REPORT DOCUMENTATION PAGE		READ INSTRUCTIONS BEFORE COMPLETING FORM
1. REPORT NUMBER	2. GOVT ACCESSION NO.	3. RECIPIENT'S CATALOG NUMBER
	AD-A104769	
4. TITLE (and Subtitle) Phase I Dam Inspection Report National Dam Safety Program Indian Rock Lake Dam (MO 31033) Franklin County, Missouri		5. TYPE OF REPORT & PERIOD COVERED Final Report

INDIAN ROCK LAKE
FRANKLIN COUNTY, MISSOURI
MISSOURI INVENTORY NUMBER 31033

PHASE I INSPECTION REPORT
NATIONAL DAM SAFETY INSPECTION

PREPARED BY: ST. LOUIS DISTRICT CORPS OF ENGINEERS
FOR: GOVERNOR OF MISSOURI
JULY 1978

PHOTO 2 Spillway cut through embankment

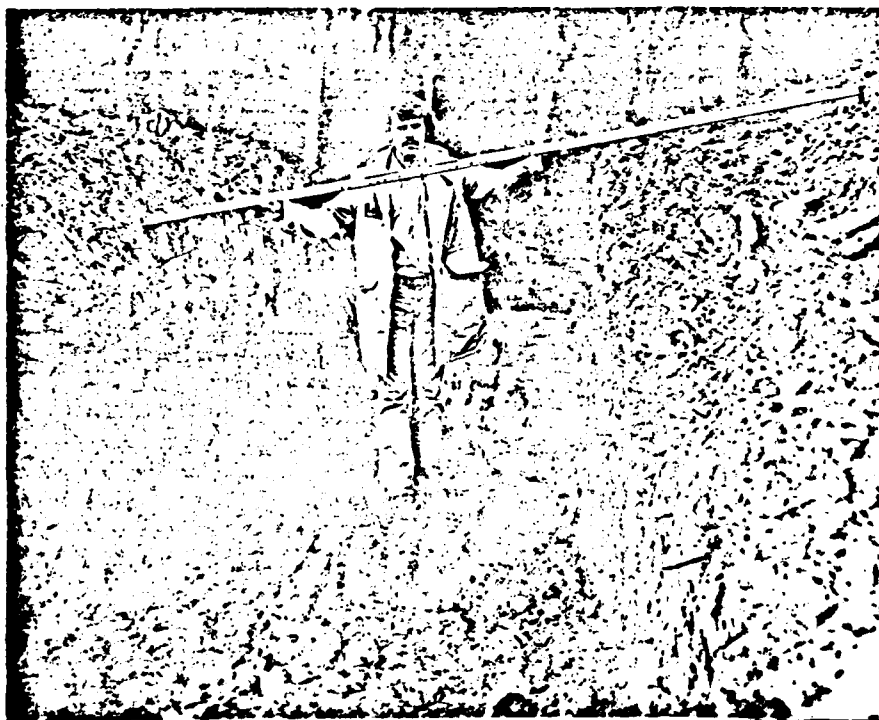
An unprotected 6-foot by 6-foot outlet cut through the embankment as an emergency spillway indicated the dam is unzoned, or of homogeneous construction in the area exposed. Numerous roots were found in the fill material (see photo 2). These roots constitute a potential seepage hazard as they decay. Sidewalls of the cut were firm but the bottom was soft from flowing water. No erosion protection was provided. This earth cut could not be expected to remain intact during any prolonged flow. Significant embankment erosion, and possible failure, would likely occur.

(3) An unprotected 6 feet by 6 feet notch had recently been cut through the embankment near the left abutment to serve as an emergency spillway. The water flowing through the notch was cutting its own exit channel parallel to the toe of the dam to the creek. (See photos 2 and 3).

d. Provide an adequately sized and erosion resistant spillway and exit channel with proper energy dissipators.

PHOTO 3 Spillway discharge

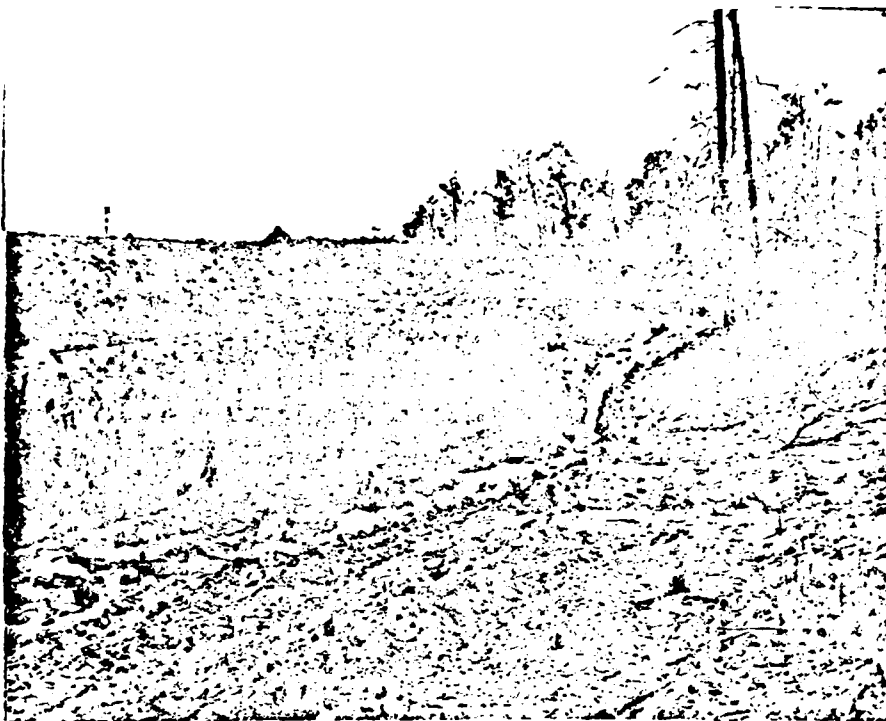
Approximately 5 cfs was flowing through the notch at the time of the inspection and that flow was eroding the exit channel. Any significant and sustained flows through the emergency spillway could cause excessive erosion of the embankment and the exit channel. The excessive erosions could threaten the safety of the dam.
